MFN 09-747

Subject: **Response to Portion of NRC RAI Letter No. 384 Related to ESBWR Design Certification Application – DCD Tier 2 Section 3.8 – Seismic Category I Structures; RAI Number 3.8-129**

**Response to Portion of NRC RAI Letter No. 384**

**RAI Number 3.8-129**

**Figure 3.8-1. Configuration of Concrete Containment**

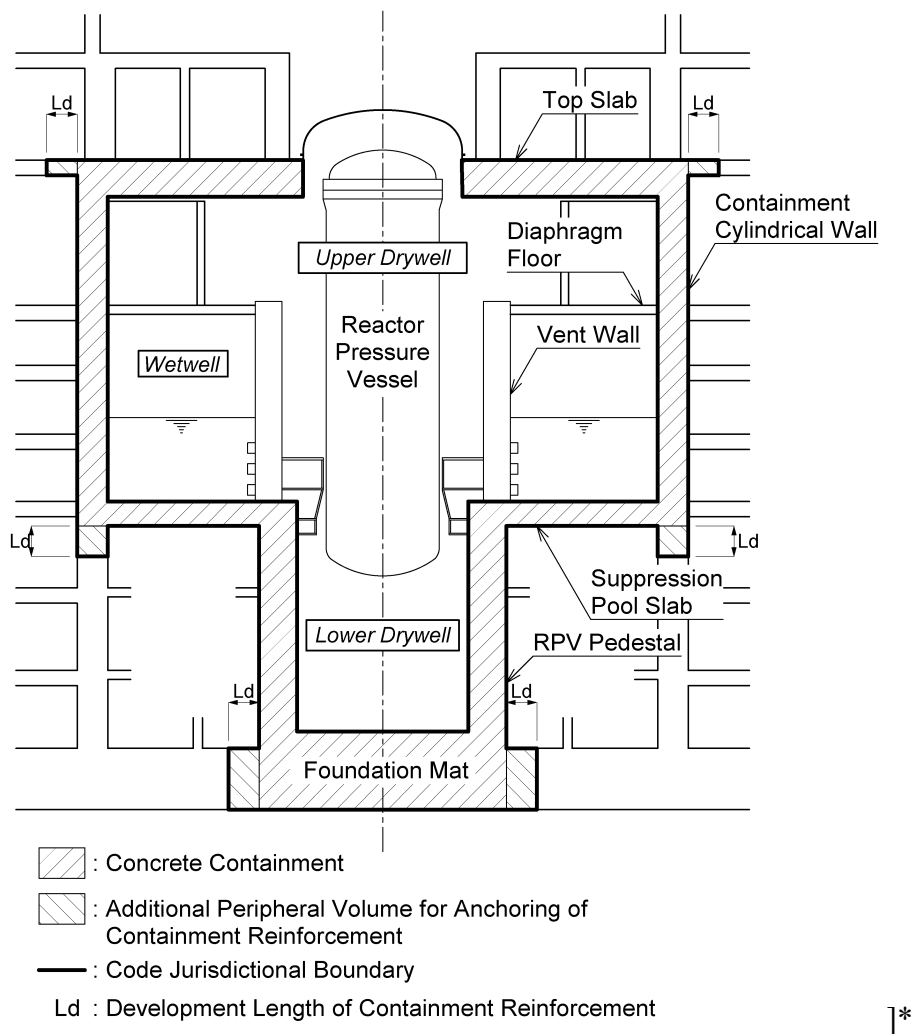
*Change Item 216: In DCD Figure 3.8-1, the [ ]\* should apply to the entire Figure. This intention is not clear the way it is inserted along an empty line in the figure.*

The opening bracket “[“ for DCD Figure 3.8-1 will be repositioned to clearly show the entire figure is included as a Tier 2\* designation.
